**Subject: Gunlake Quarry Continuation Project (SSD-12469087) MOD 1  
Response to Modification Report**

## ATTACHMENT

### COMPONENT 1: Biodiversity Values of land identified as Area 1

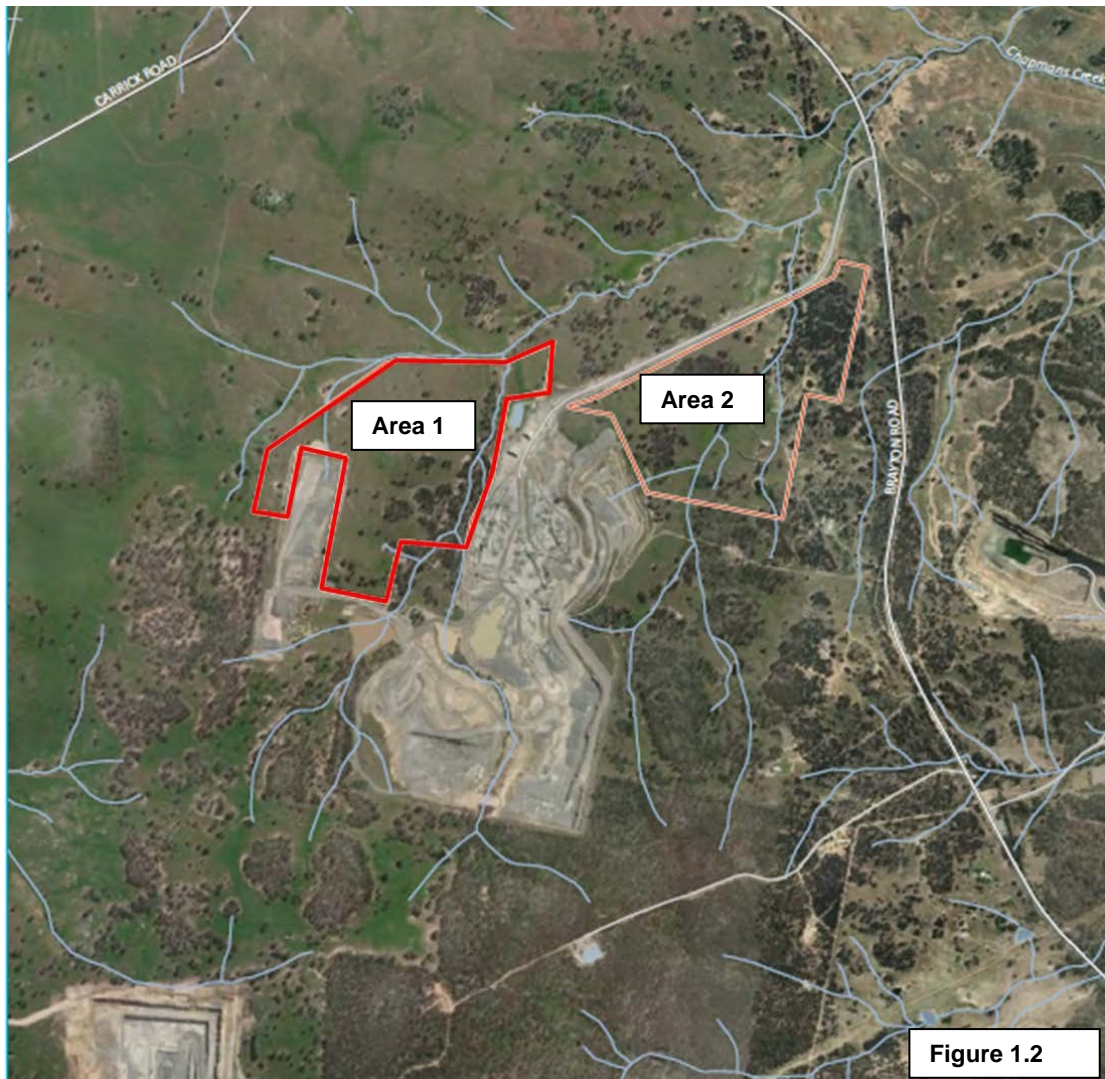
Another potential concern is that a SIX maps image of the subject land from 11 December 2013 appears to show a significant number of trees being present prior to clearing.

The BDAR maps only a relatively small area of remnant woodland being present on the subject land and considers most of it as being grassland cleared of canopy trees (Figure 4.1) but based on the SIX maps image this is likely to be a significant underestimate. As the vegetation zone identified as being remnant woodland has a VIS of 58.9, the number of offset credits may have been significantly under-calculated by assuming cleared areas were grassland with a lower VIS score when they should actually be assessed as woodland.

For comparative purposes, an extract from SIX Maps is presented below for comparison with Figure 4.1 of the BDAR, as reproduced below.

**Figure 4.1 of the BDAR reproduced for comparative purposes.**

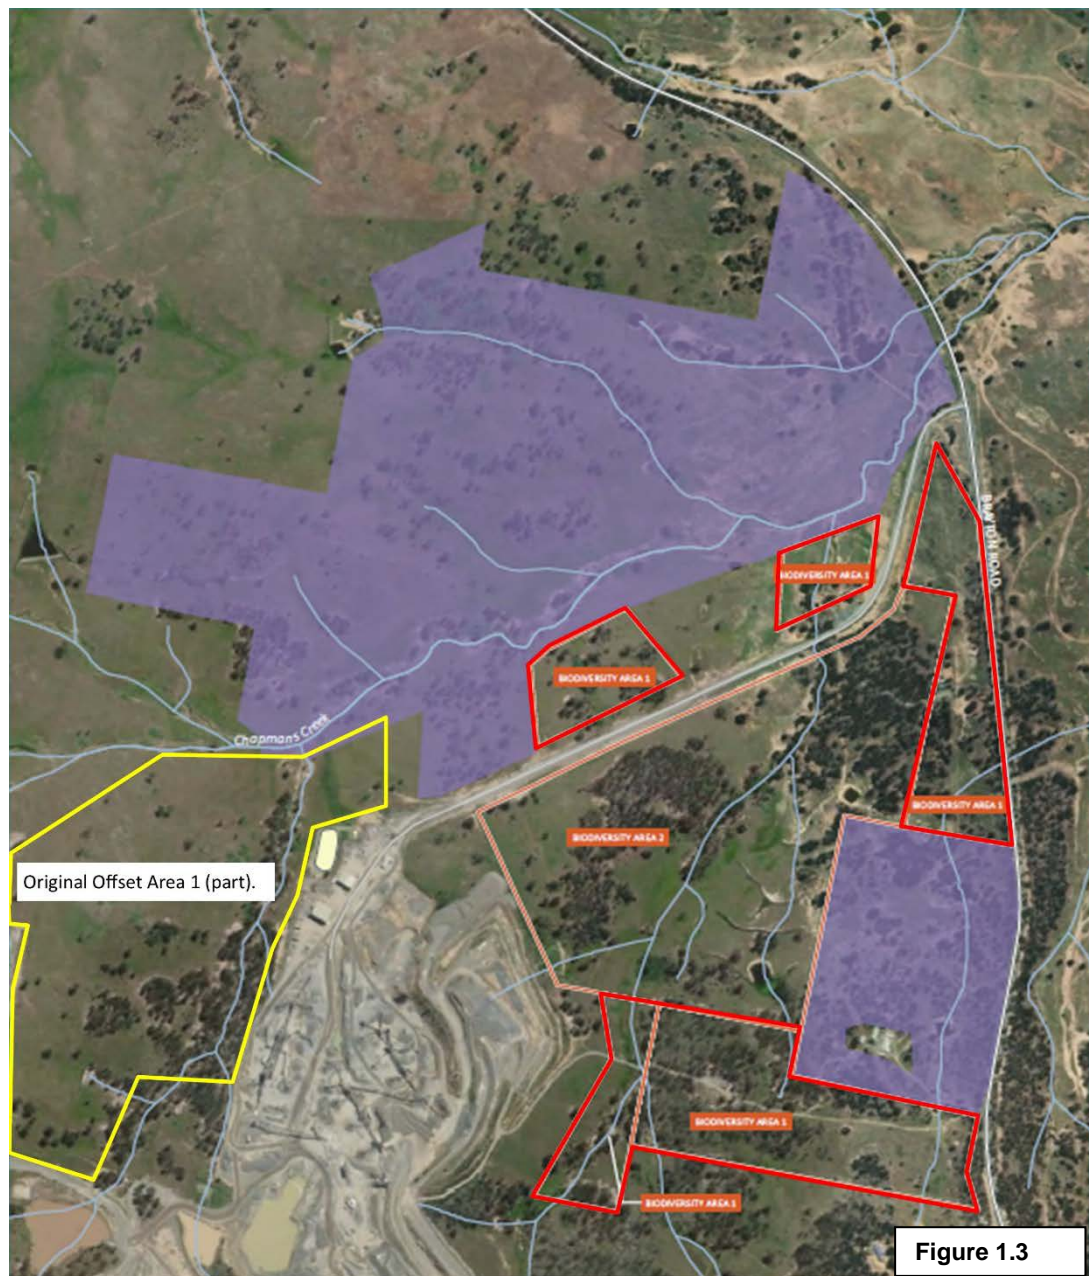
Based on available SIX Maps imagery, the area of the vegetation zone identified as woodland appears to have been underestimated. It is likely that the VIS for 4.06 hectares of grassland and 0.46 hectares of remnant woodland have been significantly underestimated and this may have resulted in inaccuracy in calculating required Biodiversity Offset Credits. The requirement to retire 17 Ecosystem Credits for PCT 3376 Southern Tableland Grassy Box Woodland (or equivalent) is likely to be a significant underestimate.
